ANTHONY DEARBORN SUBDIVISION

Engineering Comments: FINAL PLAT COMMENTS (should be addressed prior to submitting the FINAL PLAT for acceptance and signature by the City Engineer):

APPLICATION NUMBER 1 DATE January 5, 2017
APPLICANT Anthony Dearborn Subdivision
REQUEST Subdivision

DETAIL SITE PLAN

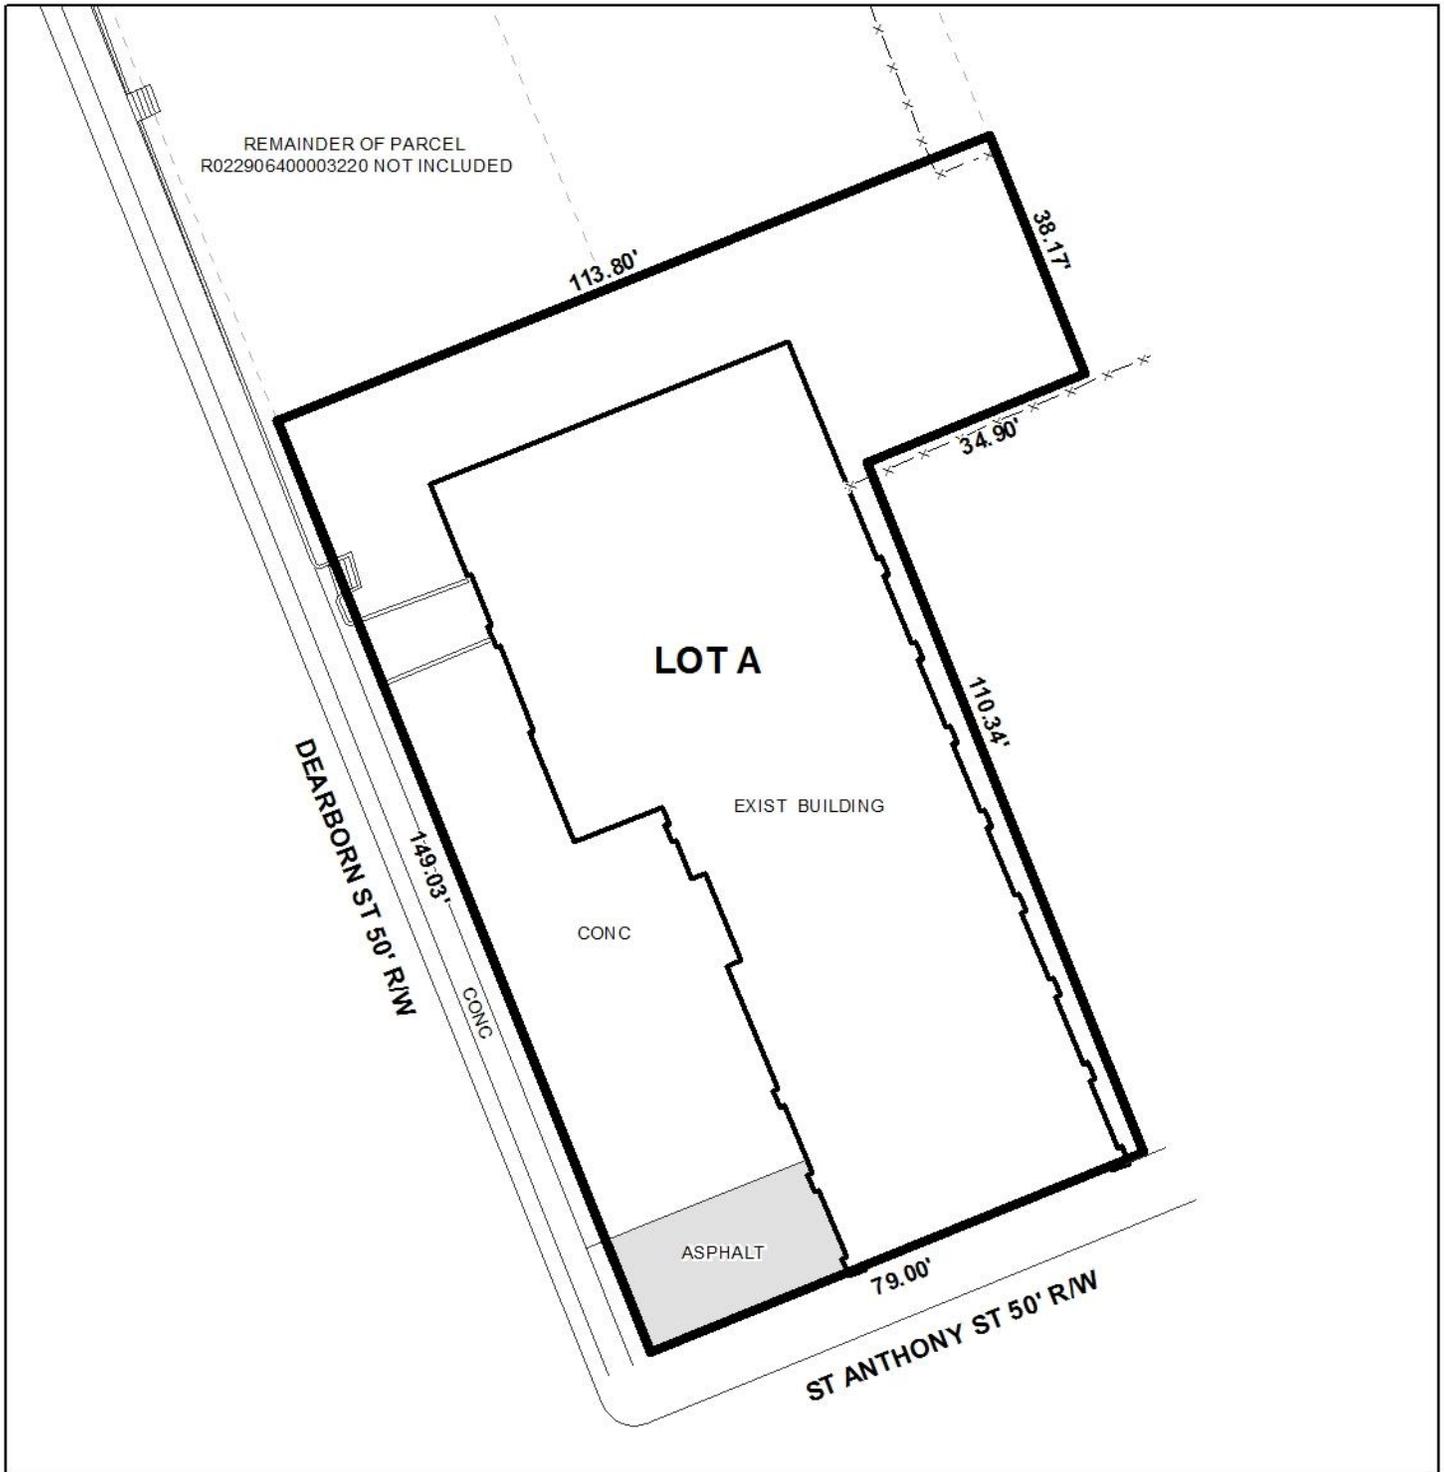
- B. Review and revise the written legal description to match the written bearings and distances.
- C. Dedicate the corner radius (25' minimum or as approved by the City Engineer and Traffic Engineer) at the Southwest corner of LOT A.

- D. Show and label all flood zones.
- E. Show and label the MFFE (Minimum Finished Floor Elevation) on each lot that contains an AE, V, or X (shaded) flood zone designation.

- F. Provide and label the monument set or found at each subdivision corner.
- G. Add a signature block for the Owner, Notary Public, Planning Commission, Traffic Engineer, and City Engineer.

- H. Provide the Surveyor's Certificate.
- I. Add a note to the SUBDIVISION PLAT stating that a Land Disturbance permit will be required for any land disturbing activity in accordance with Mobile City Code, Chapter 17, Storm Water Management and Flood Control); the City of Mobile, Alabama Flood Plain Management Plan (1984); and, the Rules For Erosion and Sedimentation Control and Storm Water Runoff Control.

maximum curb cut width is 25'. The site should be limited to one curb cut per street frontage with size, location and design to be approved by Traffic Engineering and conform to AASHTO standards. The curb cut along North Dearborn Street should be modified to only be 25' in width, with the sidewalk and curb and gutter restored.

There is no minimum building setback required in a SD-WH district; however, the lot is limited to a 10' maximum building setback. Therefore the plat should be revised to indicate the 10' maximum building setback line along all street frontages and include a note stating that a 0' setback is allowed. It should be noted that such a setback varies from Section V.D.9. of the Subdivision Regulations, and waiver of such would be required and in order.

The site, which is developed, also contains surface parking. Section 64-3.I.11.(b)(3) of the Zoning Ordinance requires that parking lots be screened. Thus, the plat should be revised to depict compliant screening along all street frontages.

- 1) *dedication to provide a 25' corner radius at the intersection of St. Anthony Street and Dearborn Street, if determined necessary by Traffic Engineering and Engineering;*

- 2) *placement of a note on the Final Plat stating that the site is limited to one 25'-wide maximum curb cut per street frontage with size, location and design to be approved by Traffic Engineering and conform to AASHTO standards, with excess curb cut areas to be removed and restored with sidewalk and curb and gutter;*

- 3) *labeling of the lot with its size in both square feet and acres, after any required dedication, or the furnishing of a table on the Final Plat providing the same information;*

- 4) *revision of the plat to illustrate a 10' maximum building setback line along all street frontages and to add a note that a 0' minimum setback is allowed;*

- 5) *compliance with Section 64-3.I.11.(b)(3) of the Zoning Ordinance regarding parking lot screening;*
- 6) *compliance with Engineering comments: [FINAL PLAT COMMENTS (should be addressed prior to submitting the FINAL PLAT for acceptance and signature by the City Engineer): A. Provide all of the required information on the SUBDIVISION PLAT (i.e. signature blocks, signatures, certification statements, written legal description, required notes, legend, scale, bearings and distances) that is required by the current Alabama State Board of Licensure for Professional Engineers and Land Surveyors. B. Review and revise the written legal description to match the written bearings and distances. C. Dedicate the corner radius (25' minimum or as approved by the City Engineer and Traffic Engineer) at the Southwest corner of LOT A. D. Show and label all flood zones. E. Show and label the MFFE (Minimum Finished Floor Elevation) on each lot that contains an AE, V, or X (shaded) flood zone designation. F. Provide and label the monument set or found at each subdivision corner. G. Add a signature block for the Owner, Notary Public, Planning Commission, Traffic Engineer, and City Engineer. H. Provide the Surveyor's Certificate. I. Add a note to the SUBDIVISION PLAT stating that a Land Disturbance permit will be required for any land disturbing activity in accordance with Mobile City Code, Chapter 17, Storm Water Management and Flood Control); the City of Mobile, Alabama Flood Plain Management Plan (1984); and, the Rules For Erosion and Sedimentation Control and Storm Water Runoff Control. J. Add a note to the Plat stating that the approval of all applicable federal, state, and local agencies (including all storm water runoff, wetland and floodplain requirements) will be required prior to the issuance of a Land Disturbance permit. K. Add a note that sidewalk is required to be constructed, and/or repaired, along the frontage of each lot, or parcel, at time of new development or construction, unless a sidewalk waiver is approved. L. Provide a copy of the FINAL SUBDIVISION PLAT to the Engineering Dept. for review. No signatures are required on this drawing. M. After addressing all of the FINAL SUBDIVISION PLAT review comments by the Engineering Dept. provide the ORIGINAL and one (1) copy of the revised Final Plat with all of the required signatures including the Owner's (notarized), Planning Commission, and Traffic Engineering signatures.];*
